Potential Amendments to the Revised Proposed Draft

March 8, 2019

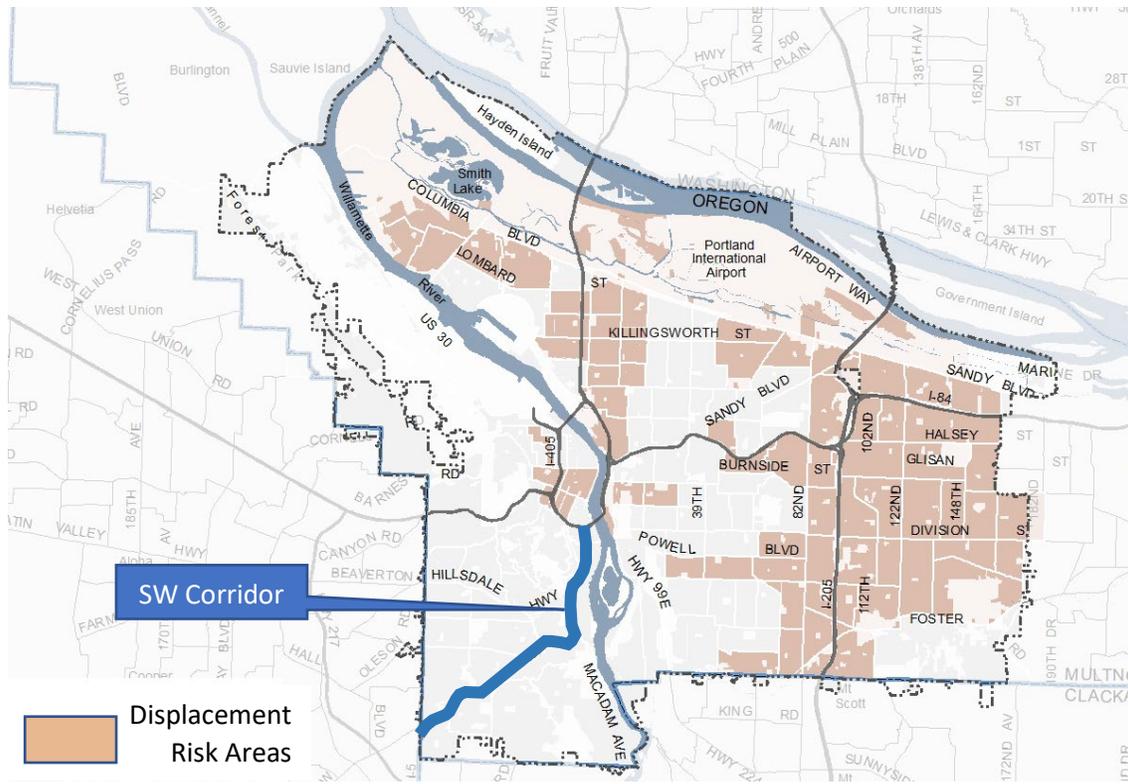
#1 – Restrict housing options in some areas [Baugh]

Amendment: Exclude the “displacement risk” census tracts and the SW Corridor (as shown in the map on next page) from allowing duplexes, triplexes, and fourplexes. In these areas, instead allow up to 3 ADUs, subject to applicable FAR limits (e.g. 2,500 sf house; 3,000 sf for house & 1 ADU; 3,500 sf for house & 2 or 3 ADUs). This limitation would last for 5 years or until such time a single-dwelling housing anti-displacement strategy is developed and implemented, including both Citywide and census tract-specific actions. The limitation would also be removed when census tracts are no longer identified as being at risk of displacement.

Rationale: To develop a policy to ensure low-income residents (80% MFI and below) and residents of color have access to affordable (80% or below) single-family units either rental or home ownership units in Portland. The focus would be on working families. Additionally, the focus would develop strategies to retain and create wealth for current home owners with incomes under 80% MFI in these areas. It is hoped the exclusion would not be removed until the City Council has received a report of good or excellent of how the anti-displacement strategy is working.

Staff position: Staff does not support this amendment, for several reasons:

- It **will alter the displacement risk analysis**, potentially leading to higher displacement of low-income renters in other areas of the city. Staff believes that a programmatic approach is better suited to adapt and respond to these changing conditions.

- While the proposed amendment provides opportunities to add the same number of units in these areas, **restricting these units to ADUs limits the unit sizes to studio or single-bedroom units**. This limits options for families in areas where displacement is a higher concern.

- Three ADUs per site will **not be a viable configuration** when considering building coverage, building code and other development rules.
- From a regulatory perspective, this would likely require establishing **another type of overlay zone**. Using a map in the zoning code to address the changing nature of neighborhood household composition is difficult, as the process to revise this map requires a legislative process and will create non-conforming development situations as the rules fluctuate and change.
